Access Compliance Report

Public Rights-of-Way

(Pedestrian Signals)

Intersection ID: N/A	Main Street:	Cross Street: N/A	Location: N/A
ADA ID: 8D175EB5A28D	Signal Type: One Push Button-APS	Overall Compliance: No	Severity Score: BTN 1: N/A BTN 2: N/A No BTN: N/A
Codes/Mitigation Info/Possible Solution		Field Measurements/Component Compliance

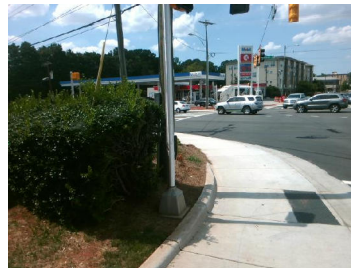
Possible Solutions: Replace Signal Push Button With APS Button on New Post. Remove & Relocate Sign.

PROW/ADA: TMUTCD 4e.08, R404.2, R406.2, R404.7.3, R209.1, MUTCD 4e.10
